DECLARATION FOR THE RECORD OF DECISION**SITE NAME AND LOCATION**

PJP Landfill

Jersey City, Hudson County, New Jersey

RECORD OF DECISION

Figure 2-1
Proposed New Fence
(PHASE III FS, July 22, 1998)

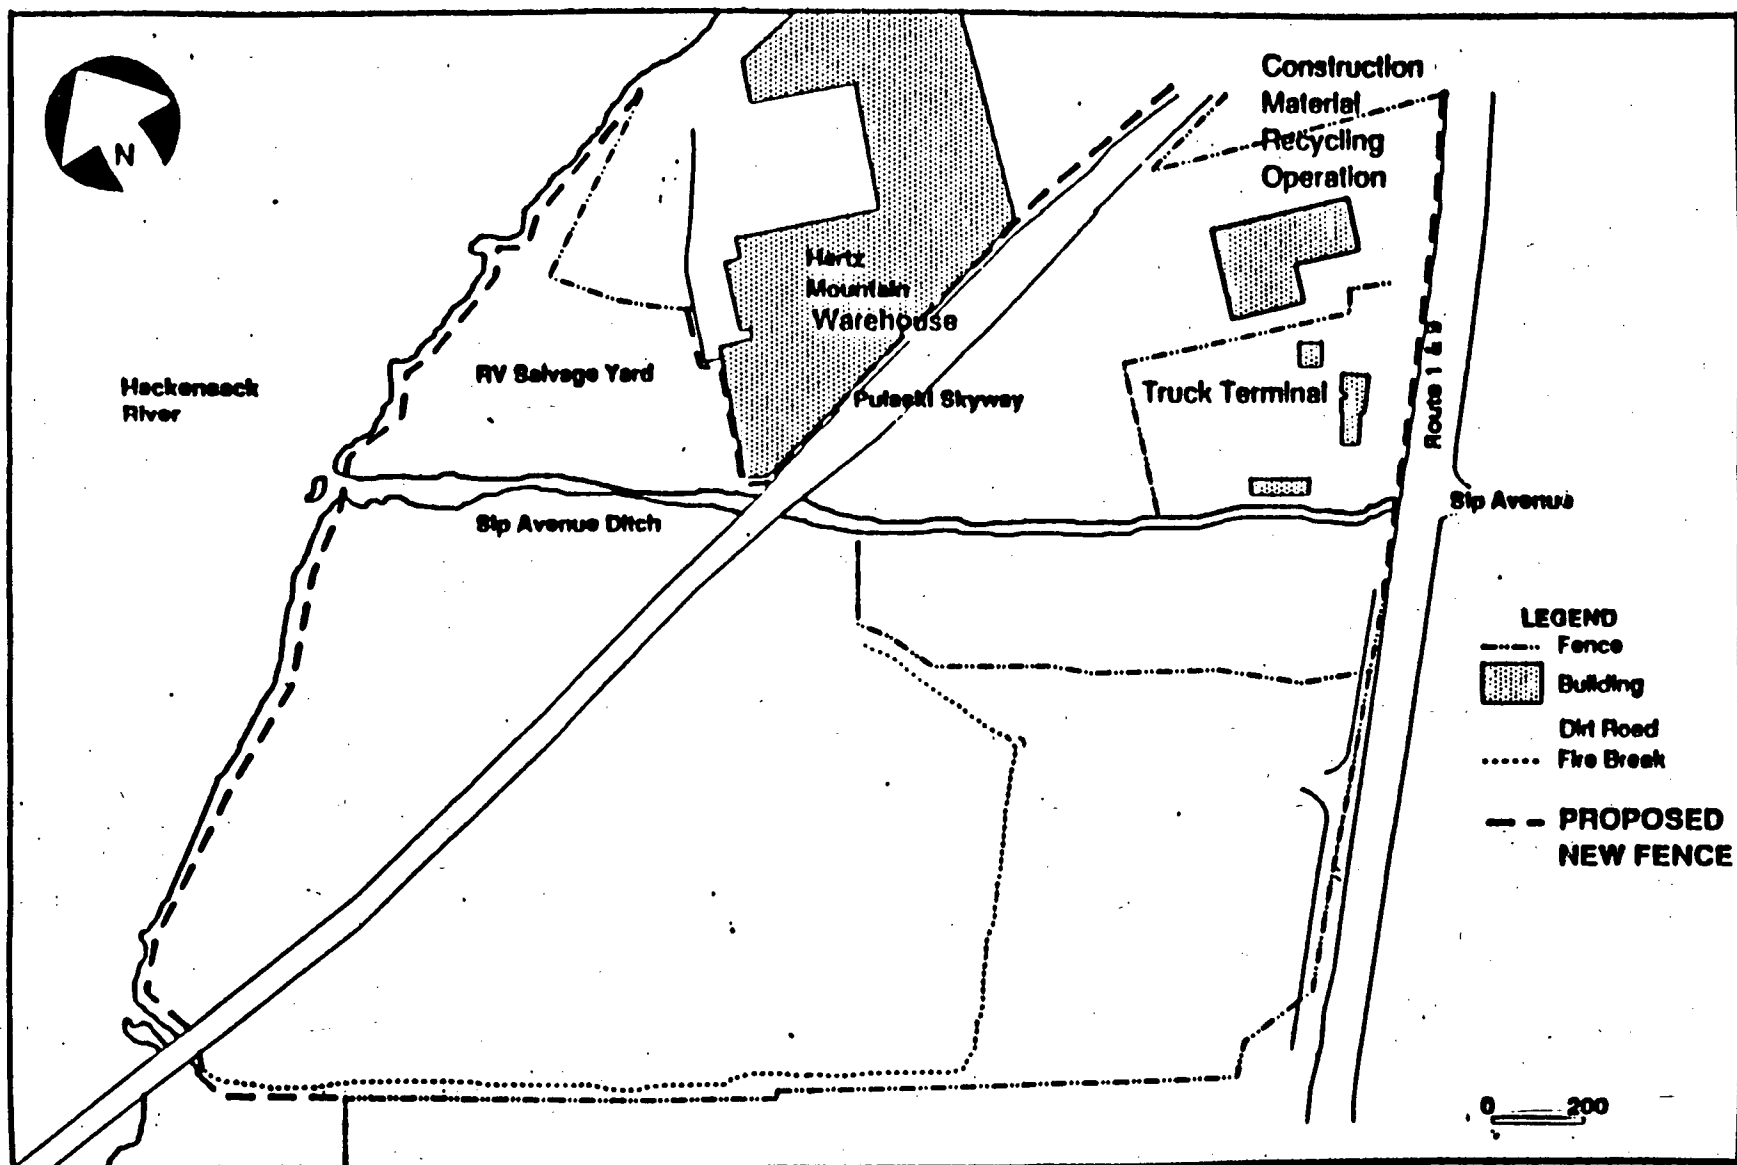
The NJDEP Proposed Plan includes full site fencing for the entire 87-acre site allegedly encompassing the PJP Landfill site (See Figure 2-1, from ICF Phase III Feasibility Study Report dated July 22, 1993, attached herewith). This should be reviewed with respect to the current site uses and fencing should be designed such that it does not interfere with the use of the properties by their respective owners. In particular, fencing (and capping) of currently occupied buildings and paved areas to the north of the Sip Avenue Ditch along Routes 1 & 9 is not justified. This is supported by NJDEP's decision to not fence (or cap) the property occupied by Hartz Mountain.
